ROADWAY P&P

GRADING & EROSION CONTROL PLANS
GRANDVIEW RESERVE FILING NO. 1
4 SITE INVESTMENTS, LLC (D.R. HORTON)
SF-22-XXX **SF2311**

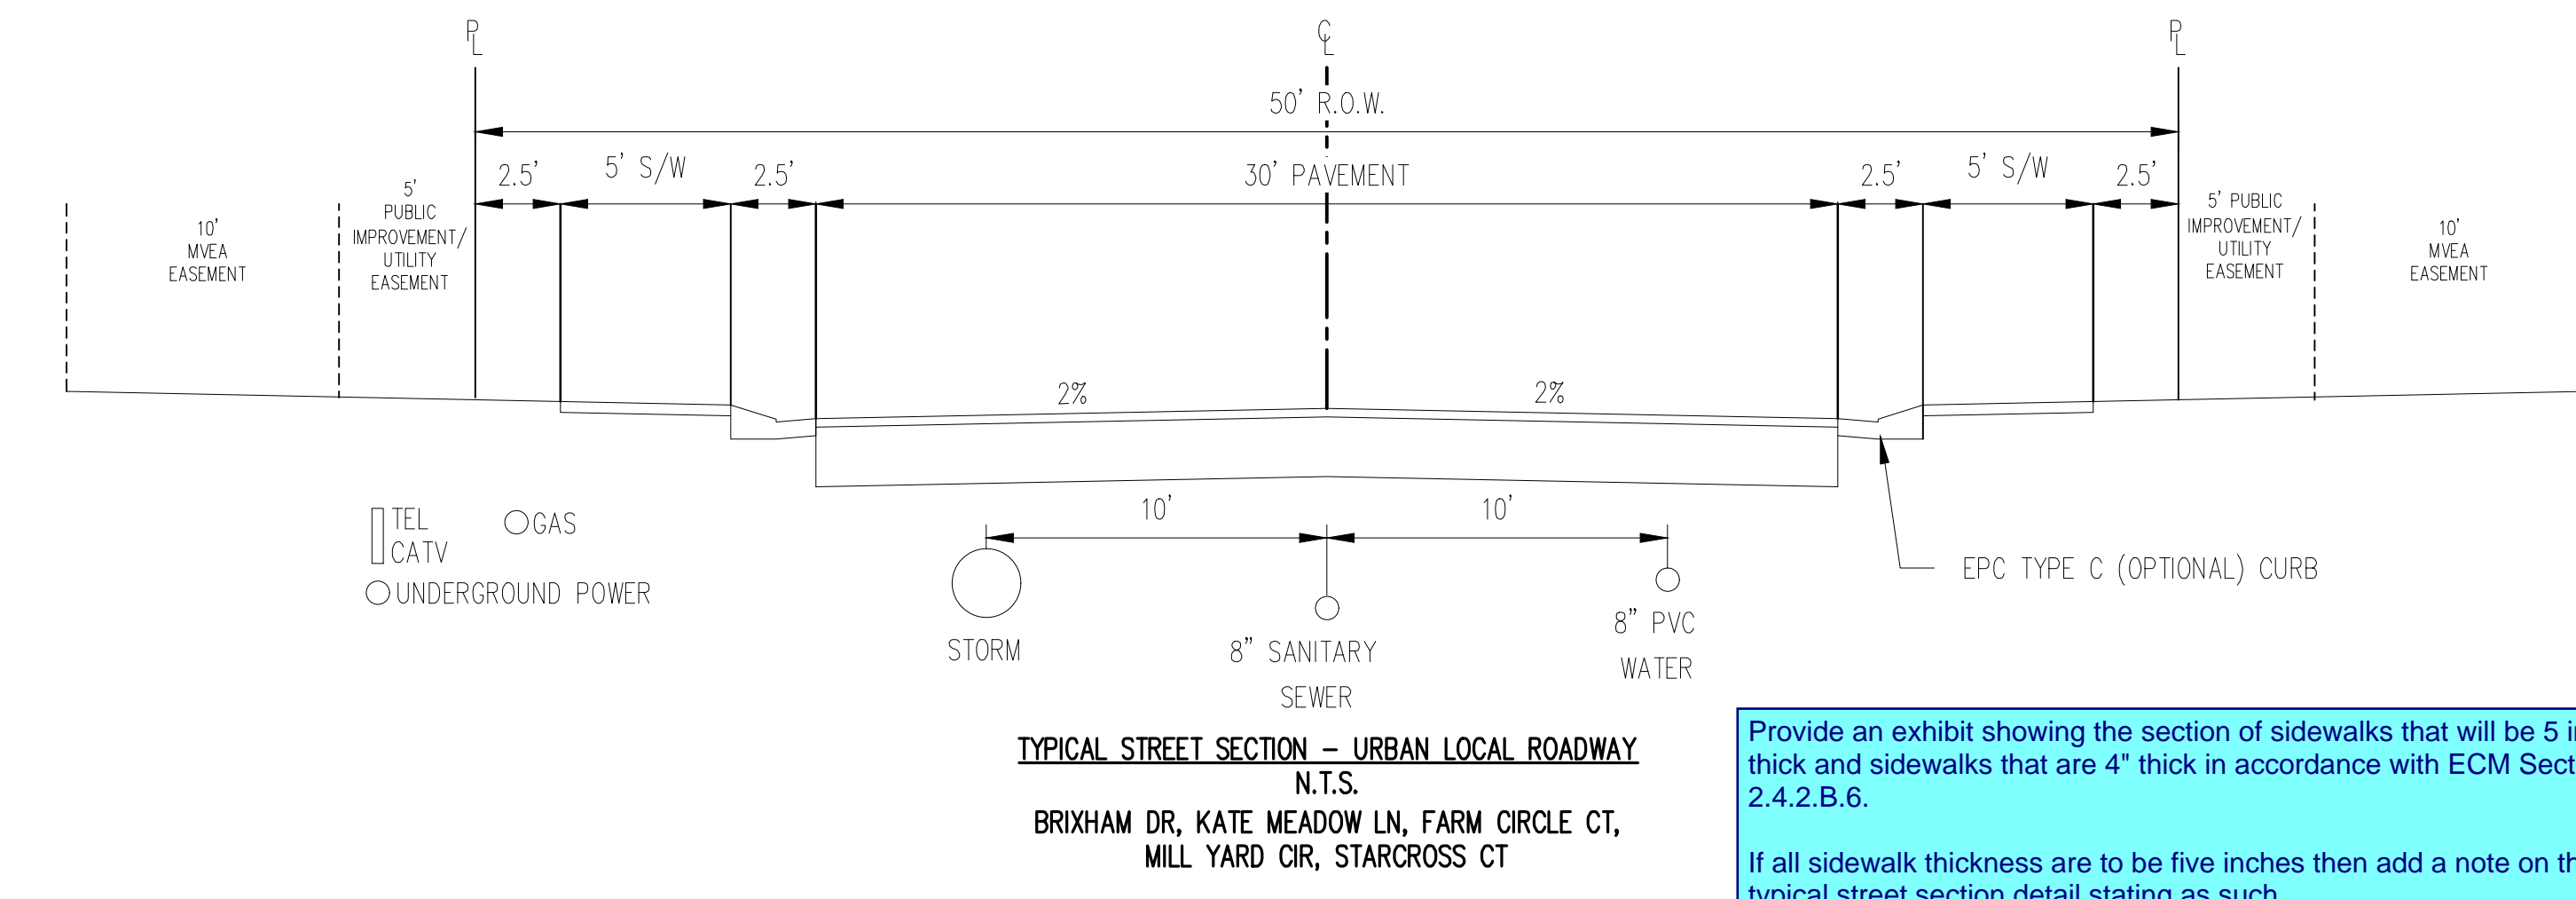
Provide an exhibit showing the section of sidewalks that will be 5 inch thick and sidewalks that are 4' thick in accordance with ECM Section 2.4.2.B.6.

If all sidewalk thickness are to be five inches then add a note on the typical street section detail stating as such.

MILL YARD CIR (D) - PUBLIC 50' R.O.W.
25 MPH DESIGN SPEED (LOCAL)
SCALE: 1"=30'

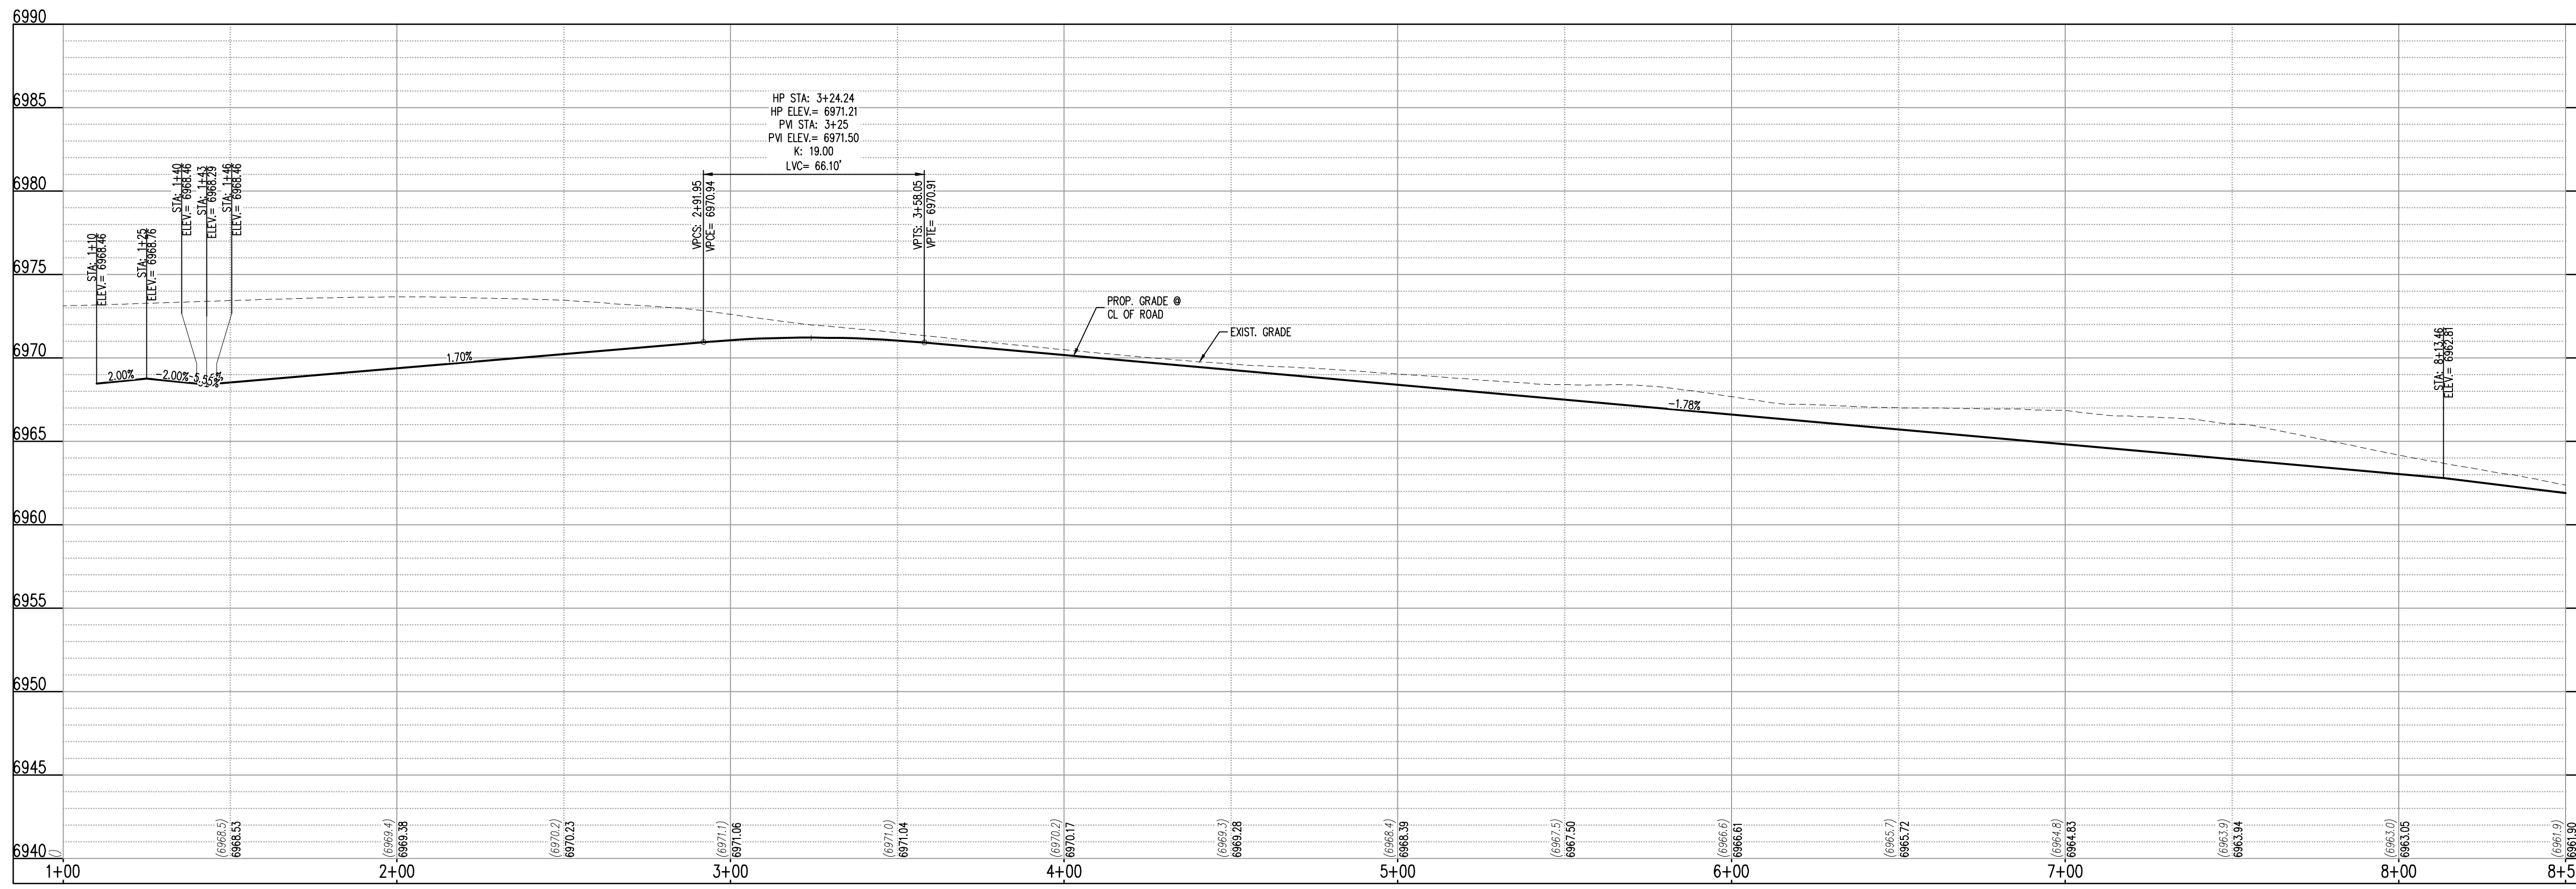
Update the ROW and easement to include the chamfer for the sight distance triangle per ECM detail SD_2-77.

NOTE: ALIGNMENT AND PROFILE IS ALONG EDGE OF PAVEMENT

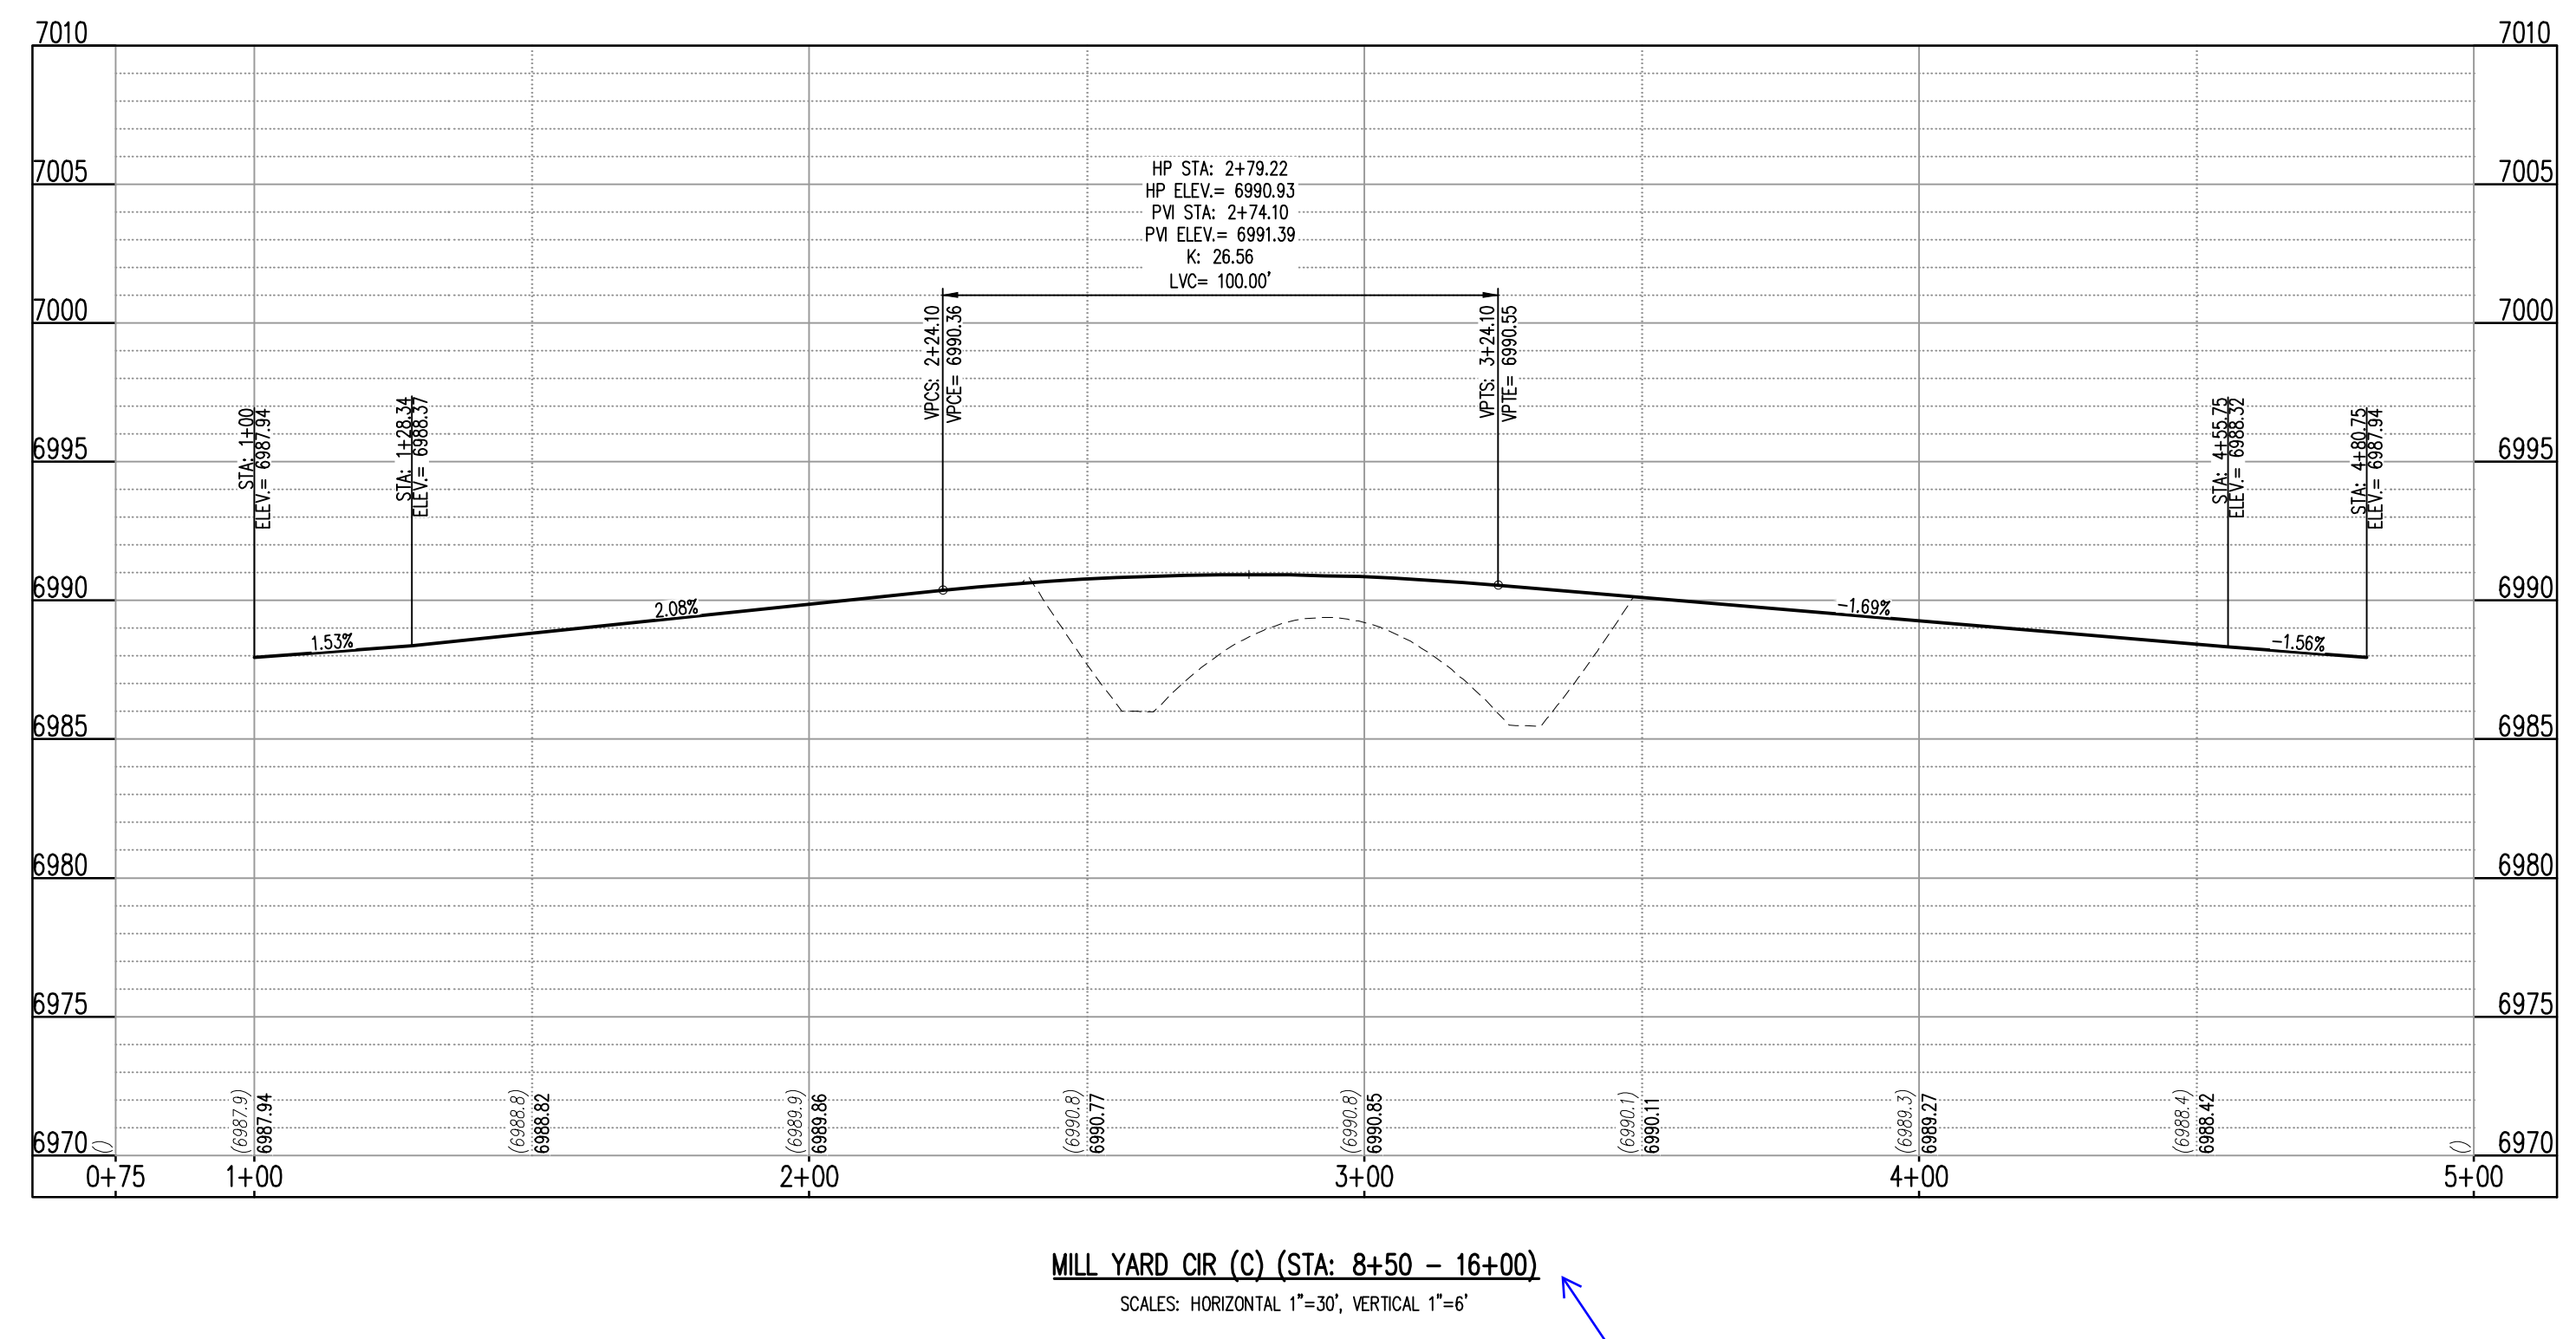
Label does not match STA shown
